North-South 400kV Interconnection Development

**Response to the
Issues Raised in
Submissions /
Observations**

Figure 19.4 Map indicating locations of ringforts and enclosures, indicated in orange, in the vicinity of Rafferagh and Ardragh.

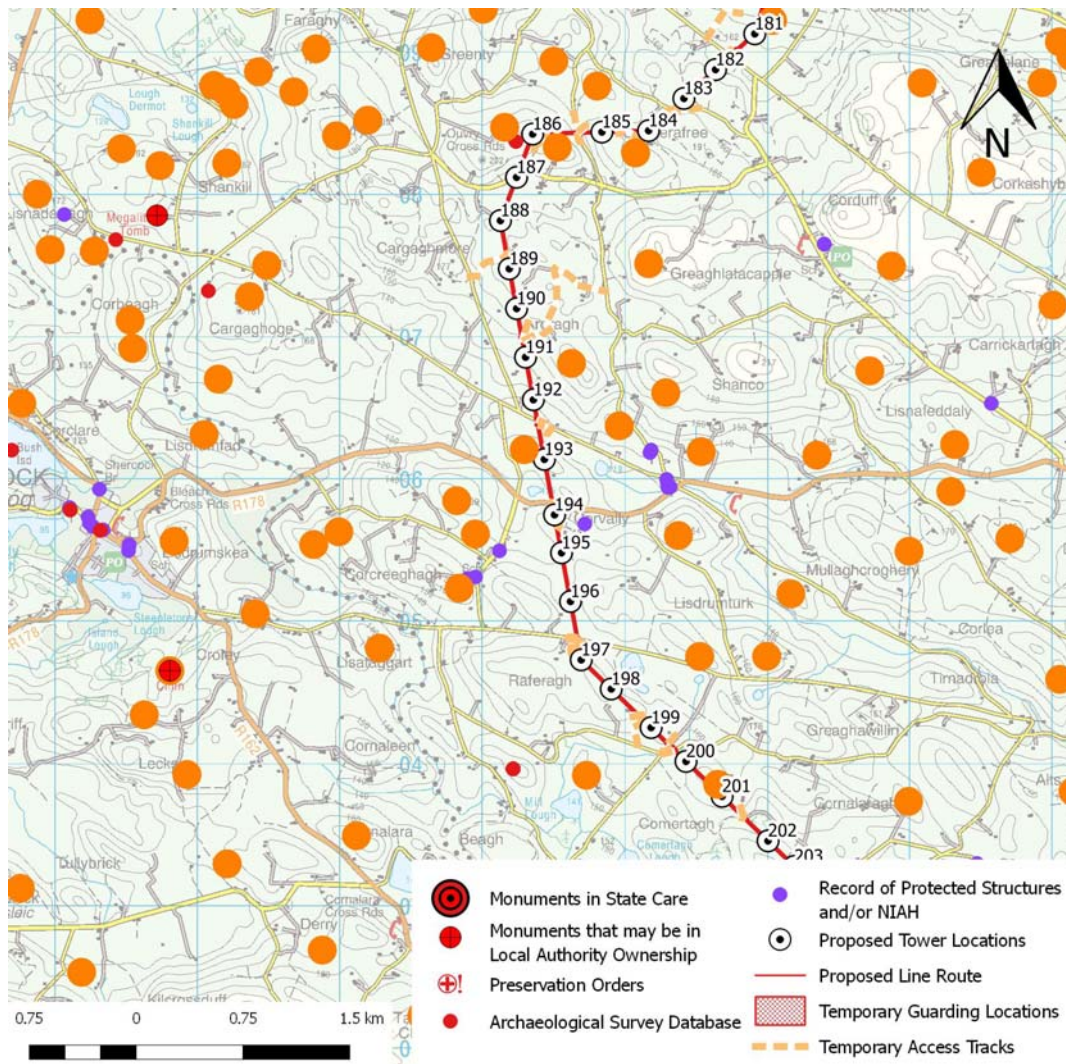
- 189 As illustrated below there are numerous ringforts and enclosures in the general area, some surviving and some no longer extant, it is acknowledged that there may be some bisection of views between some enclosures and ringforts. (Figure 19 4).
